Product Information Sheet

CANFORD SPARE MICROPHONE CAPSULE 200 SERIES HEADSETS - NOV 2021 CHANGE DETAILS

27-802 CANFORD SPARE MICROPHONE CAPSULE For DMH220/225, SMH210, headset, 200 ohms

27-802 Mic Capsule - Post November 2021

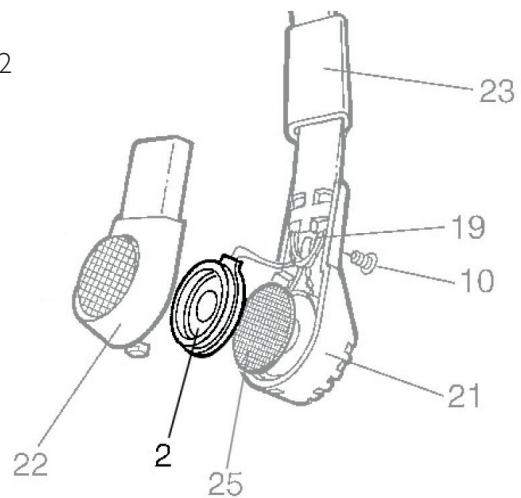
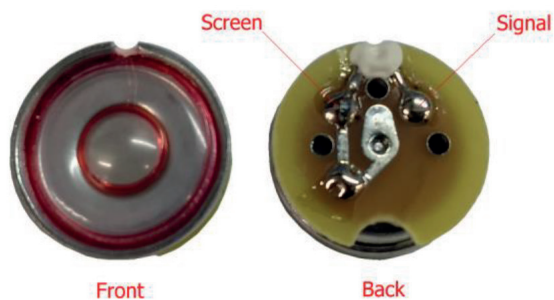
From **November 2021** the spare microphone capsule for the Tecpro 2 series headsets and Canford 200 series headsets has changed.

Newer model has the signal and screen contacts on the back of the capsule assembly. Previously contacts were front facing as illustrated below

Pre Nov 2021 Capsule
contacts on the front

Post Nov 2021 Capsule
contacts on the back
